TO: Mercedes-Benz Dealer Principals, General Managers, Sales Managers, Service Managers, Parts Managers	FROM: Gregory Gunther, Department Manager, Vehicle Compliance and Analysis, Engineering Services
RE: <b>Emission Modification Notification – [[2020050027]] MY 13 E350 BlueTec Update – Emission Modification Category (EMC) #7</b>	DATE: April 7, 2022

Campaign No. 2020050027, April 2022

SUBJECT: **Model E-Class diesel vehicles (W212 platform)**  
**Model Year 2013**  
**Modification to the emission control system**

**Figure 5**

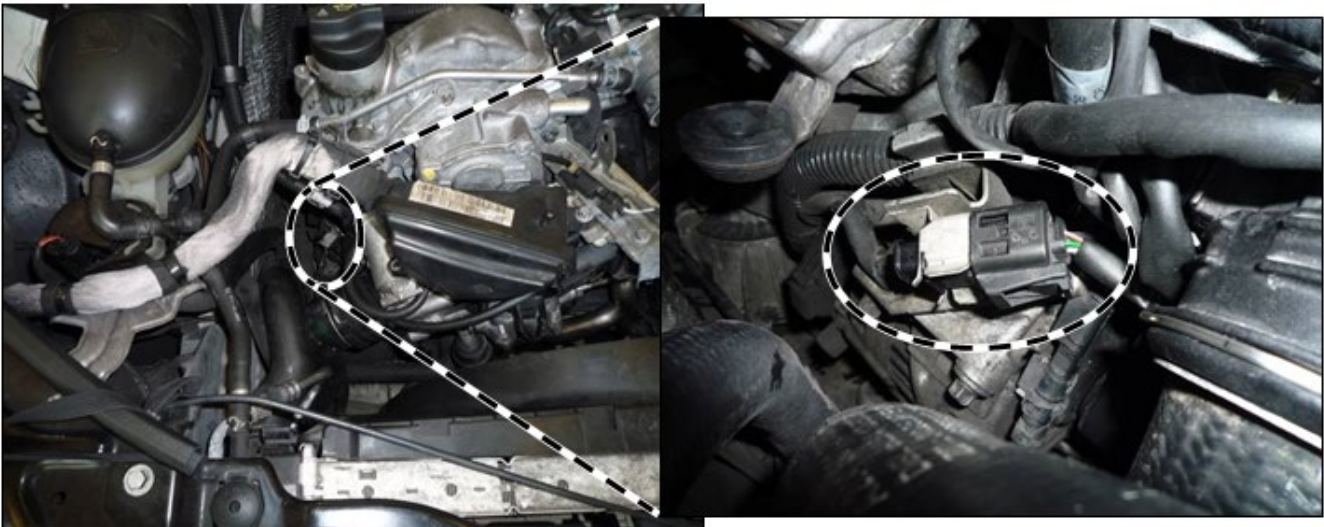
7. Install screw plug (N 007 604 018 109) and sealing ring (A 021 997 62 45) for the O2 sensor port on the DPF (**Nm** 50, **Figure 5**).

**i** The O2 sensor is **no longer** needed!

Figure 8

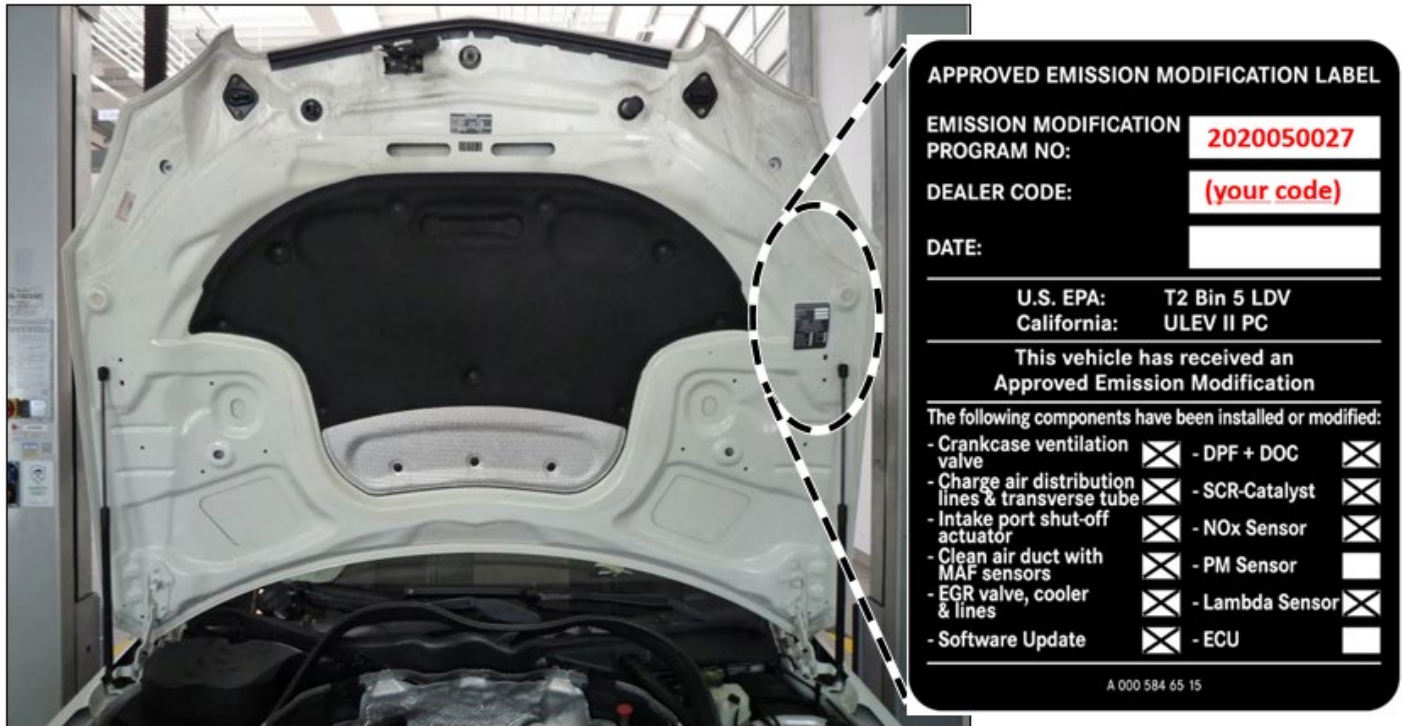
13. Clean the bonding surface area of the hood and apply the adhesive label (A 000 584 65 15) (Figure 8).

**i** The fields on the label must be filled in accordingly. Please use black permanent marker. Refer to XENTRY procedure.

**i** The adhesive label can be attached to the hood **during** the software update of the control units.
